Memorandum

RE: **P.Z. 09-2020 Total Access Urgent Care (13426 Olive Blvd)**: A request for a change in zoning from a “C-8” Planned Commercial District to a “PC” Planned Commercial District for a 3.23 acre tract of land located south of Olive Boulevard, east of North Woods Mill Road (16Q330911).

Planning Commission Vote Report

Petition: **P.Z. 09-2020 Total Access Urgent Care (13426 Olive Blvd):** A request for a change in zoning from a “C-8” Planned Commercial District to a “PC” Planned Commercial District for a 3.23 acre tract of land located south of Olive Boulevard, east of North Woods Mill Road (16Q330911).

Figure 4: Preliminary Development Plan

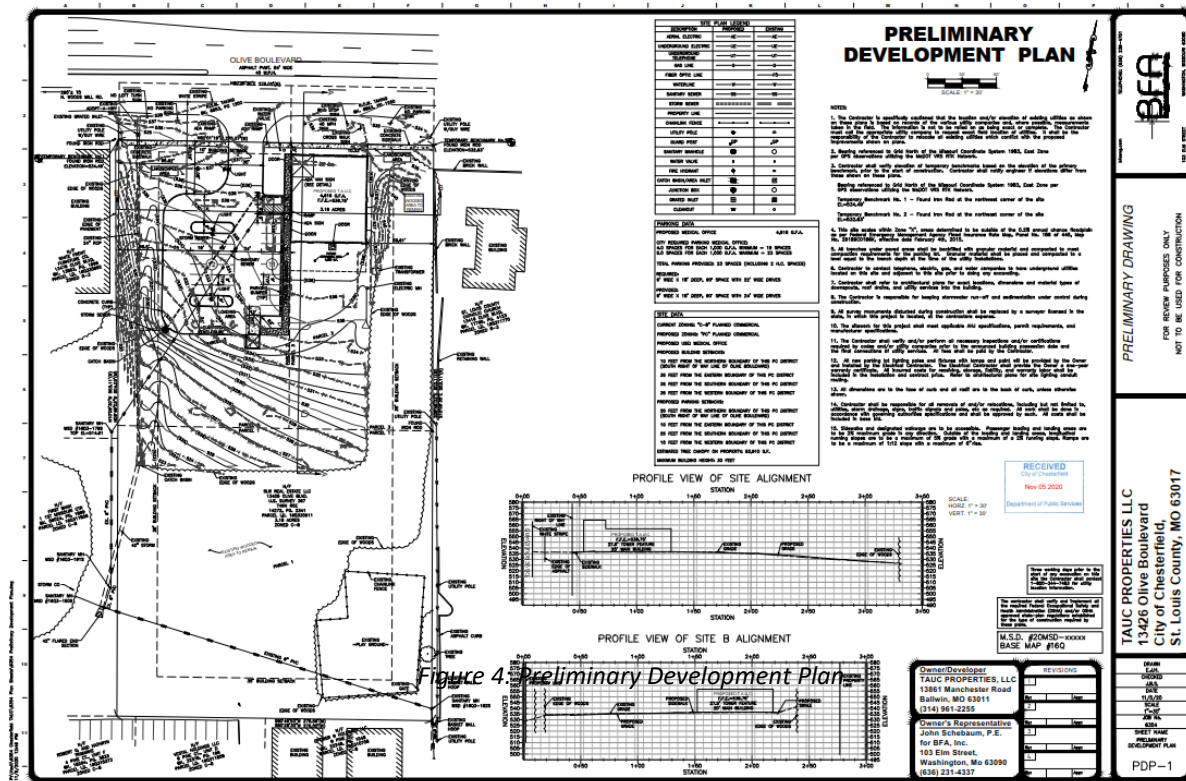
1. **Setbacks:** There was considerable discussion by both Planning Commission and the attendees regarding the requested 10' setback from Olive Boulevard. Specific concerns included the appropriateness of the setback given the 30' landscape buffer requirement along arterial roadways. Provide a response that necessitates the 10' setback.

2. **Landscape Buffer:** Similar to Issue Comment 1, there was discussion regarding the required 30' landscape buffer in contrast to the proposed 10' landscape buffer. Provide a response that necessitates the 10' landscape buffer.

- A reduction in the landscape buffer requirement along Olive Boulevard from the required thirty feet (30') to twenty feet (20'). The applicant had previously proposed a buffer of ten feet at the Public Hearing.
- Utilization of the existing access into the site, so no new access points are required.

The applicant revised the proposed setback from Olive Boulevard from their initial request of 10' to 20'. The applicant noted that the request is driven by the need for visibility from Olive Boulevard, particularly with the close position of the building on the adjacent property to the west to Olive Boulevard. Per the applicant's response, prominent visibility from a main roadway is crucial for patients in need of services to locate the facility. The applicant further added that the building will be designed in a way that is integral to the community of the City of Chesterfield.

The applicant responded that the existing Steak 'n Shake building has a landscape buffer that is less than 20'. The applicant has proposed a 20' landscape buffer between the building and Olive Boulevard, with substantial amounts of landscaping in other areas of the site.
